FPD-LINK Deserializer

Title		
Size	Number	Revision
B		
Date:	19-Aug-2022	Sheet of
File:	D:\RD5-Elin\Protel 99SE\321W-GL0D\Drawings\321W-GL0D_20220818-1.ddb

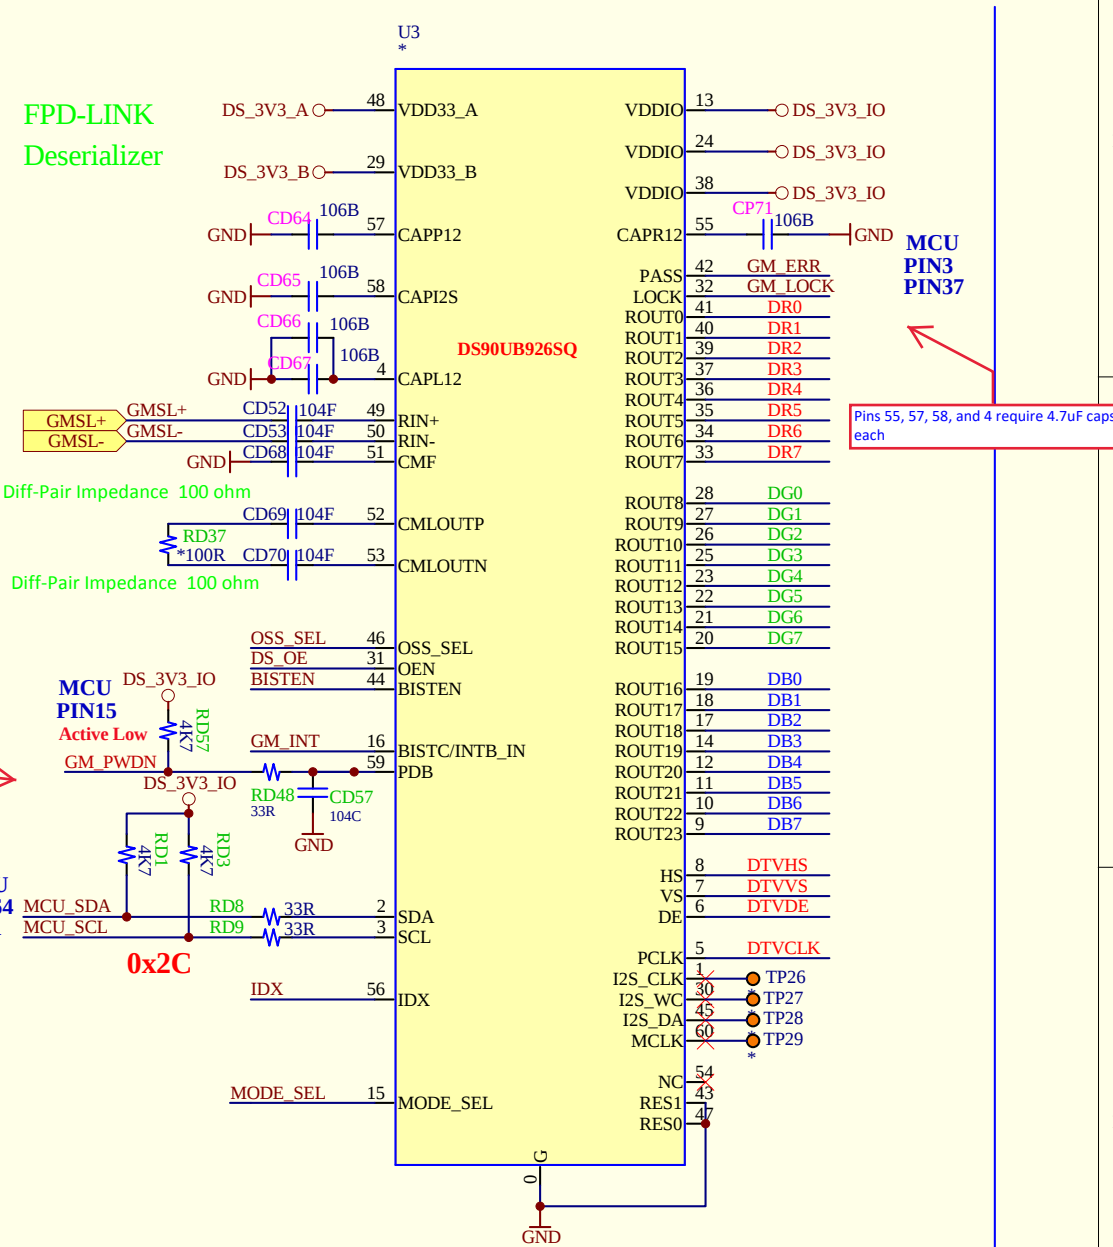
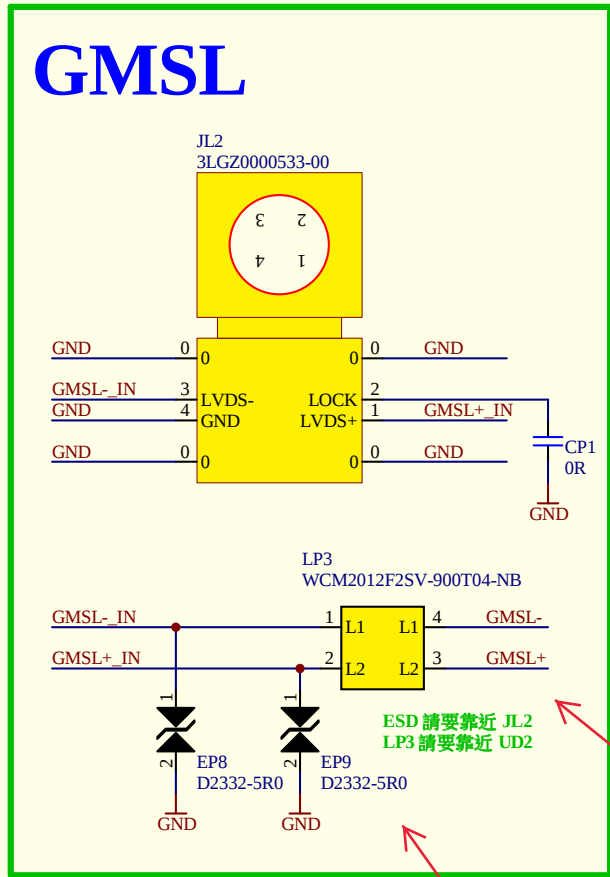
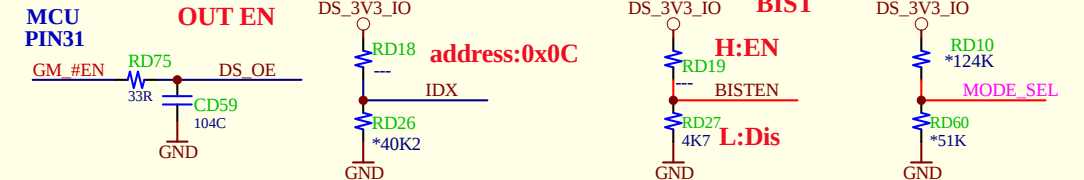
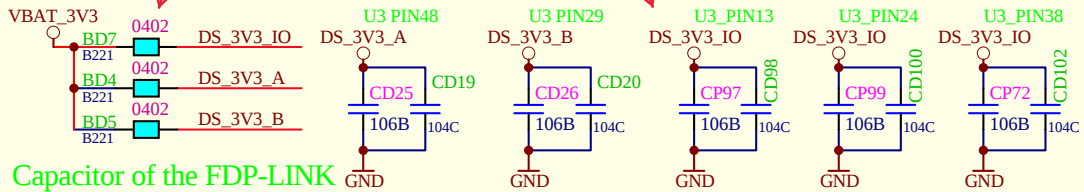
Can't see spec of FBs. Ensure DC and high frequency impedance meet specs of datasheet figure 24

Pins 48, 29, 13, 24, 38 each require 4.7uF at each pin

0x0C is not a strappable address for 926. See datasheet table 10 for strap address options and recommended resistors

CD57 should be >=1uF to ensure PDB delay

Can't find datasheet for ESD diodes. Make sure these are ultra low capacitance and small package to help with signal integrity. Similar spec to TPD1E01B04-Q1 would be ideal

Can't find differential insertion loss specs for this CMC. Suggest similar spec to DLW21S2900HQ2L to avoid insertion loss impact
